SUBJECT : Hyundai ImageQuest Co., Ltd.
FCC ID: PJIL19A00001
FCC Part 15 Subpart B Certification

Transmitted herewith, on behalf of Hyundai ImageQuest Co., Ltd. is an application for a Class II Permissive Change Certification of the following 19-inch LCD Monitor:

FCC ID : PJIL19A00001
Model/TYPE : L19T/ L19A00000

• Solution for EMI

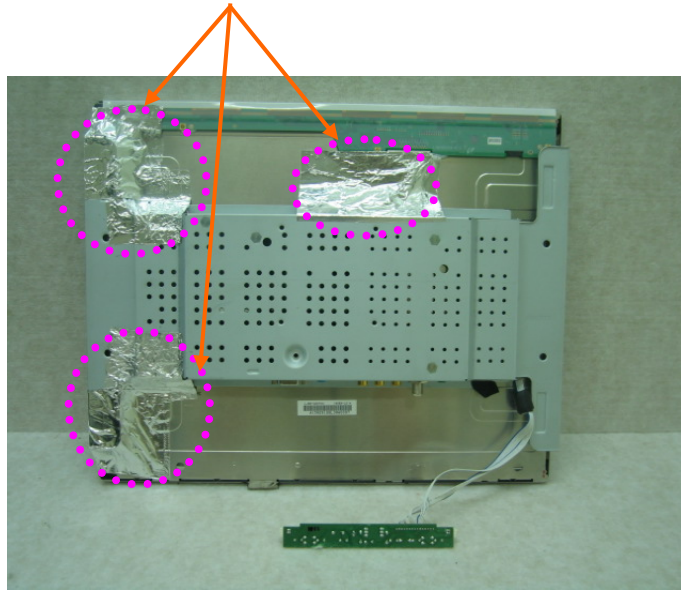
1. Attach aluminum tape on the frame and LCD Rear panel.

2. Apply a ferrite Core to the OSD cable
